**MODEL:** Super G3 Fax Board-J1

**SUBJECT:** Installation of Fax Board-J1

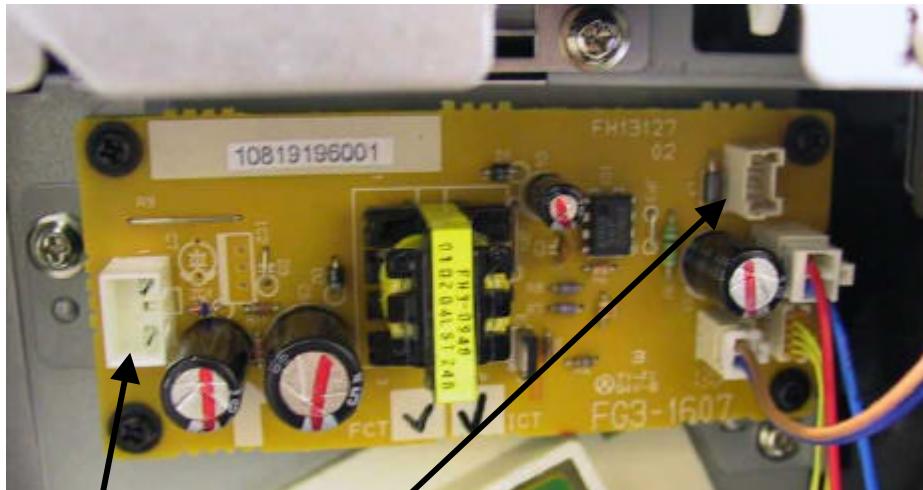
It has been brought to our attention that the installation procedure provided with the fax board, (page 3, item 5), shows 2 cables from the fax board connecting to the off hook detection PCB. In fact only one cable will be present. When installed, a total of three cables are connected to the off hook detection PCB, leaving two connectors unused.

To / From Fax  
Board J1

**THESE CONNECTORS ARE NOT USED**
